Access Compliance Report

Public Rights-of-Way

(Curb Ramps)

Intersection ID: 14705	Main Street: ALBEMARLE_RD	Cross Street: LYNTON_BV	Location: SW
ADA ID: 7C625A220BFC	Ramp Type: Perp	Initial Pass/Fail: Fail	Overall Compliance: No
Severity Score: 21.25			
Codes/Mitigation Info/Possible Solution		Field Measurements/Component Compliance

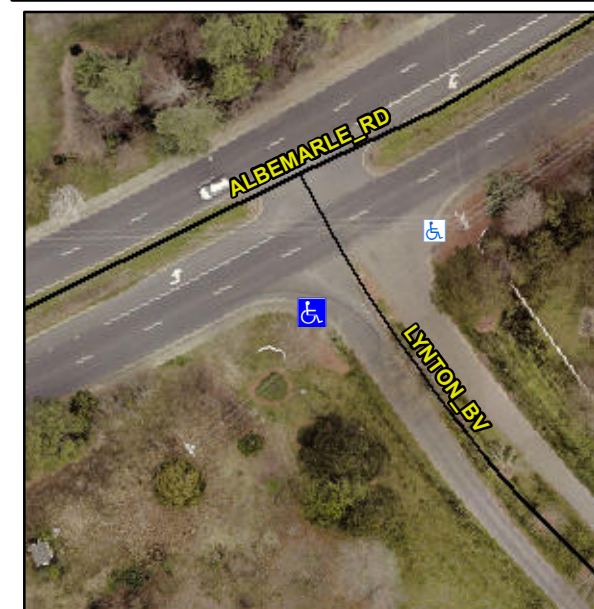
Not Found, R304.5.1, R304.2.2

Compliance	Description	Data	Compliance	Description	Data
N/A	Ramp Length (in)	60.5	No	Ramp Slope (%)	9.3
No	Ramp Width (in)	45.0	Yes	Ramp XSlope (%)	1.0
N/A	Flare Type LT	N/A	N/A	Flare Type RT	N/A
N/A	Flare Slope LT (%)	N/A	N/A	Flare Slope RT (%)	N/A
N/A	Flare Traversable LT?	N/A	N/A	Flare Traversable RT?	N/A
N/A	Landing Length (in)	N/A	N/A	DWS Provided?	N/A
N/A	Landing Width (in)	N/A	N/A	DWS Contrast?	N/A
N/A	Landing Slope (%)	N/A	N/A	DWS Length (in)	N/A
N/A	Landing X Slope (%)	N/A	N/A	DWS Full Width?	N/A
N/A	Landing Curb? (Y/N)	N/A	N/A	DWS Offset (in)	N/A
N/A	Shared Landing?	N/A			
N/A	Gutter Ponding?	N/A	N/A	Gutter Slope (%)	N/A
N/A	Gutter Lip Ht (in)	N/A	N/A	Gutter X Slope (%)	N/A
N/A	Painted X Walk1?	No	N/A	Painted X Walk2?	N/A
	X Walk 1 Direction	To E		X Walk 2 Direction	N/A
N/A	X Walk 1 Width (in)	N/A	N/A	X Walk 2 Width (in)	N/A
	X Walk 1 Slope (%)	2.7		X Walk 2 Slope (%)	N/A
	X Walk 1 X Slope (%)	0.6		X Walk 2 X Slope (%)	N/A

Remove & Replace Entire Ramp.
